FIGURE 7.6-1 NEUTRON MONITORING SYSTEM IED SH 1 OF 4

FIGURE 7.6-5 PROCESS RADIATION MONITORING SYSTEM IED (Sheet 1 of 11)

FIGURE 7.6-12 SUPPRESSION POOL TEMPERATURE MONITORING SYSTEM IBD (Sheet 1 of 6)

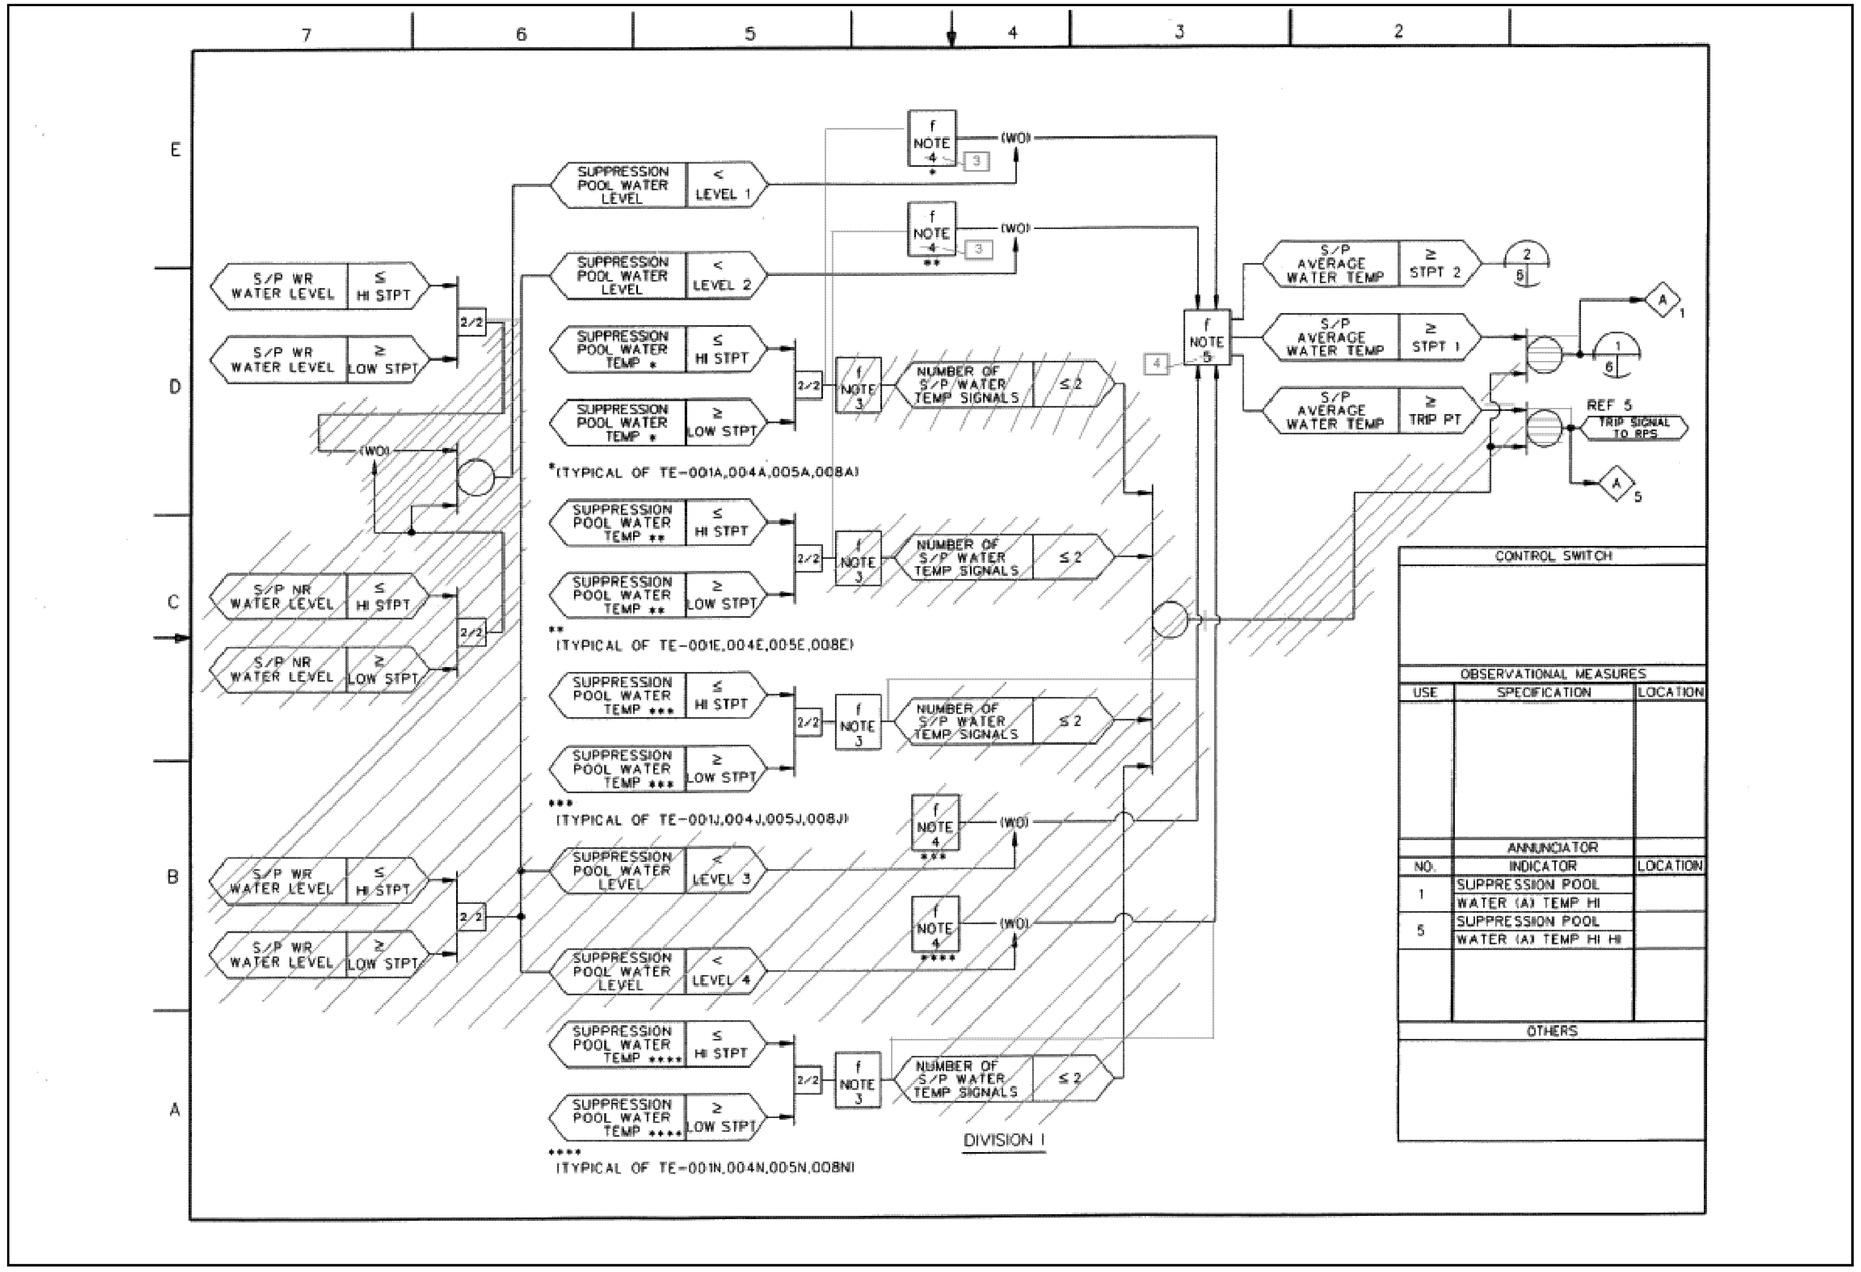
STPT = SETPOINT
NR = NARROW RANGE
~~WR = WIDE RANGE~~

1. SUPPRESSION POOL TEMPERATURE SIGNALS ARE PROCESSED BY POOL WATER LEVEL SIGNALS. SEE REFERENCE DOC 1.
2. SETPOINTS ARE REFERENCE VALUES.
3. ~~SUM TO DETERMINE NUMBER OF INPUTS (1-4).~~
4. ~~SUM OF UP TO 4 TEMPERATURES.~~
5. ~~AVERAGE OF 12 TO 16 TEMPERATURE INPUTS.~~

3. CALCULATE THE STRING AVERAGE TEMPERATURE (4 TEMP. SENSORS/STRING).
4. CALCULATE THE DIVISIONAL S/P WATER BULK TEMPERATURE (4 STRINGS/DIVISIONS).
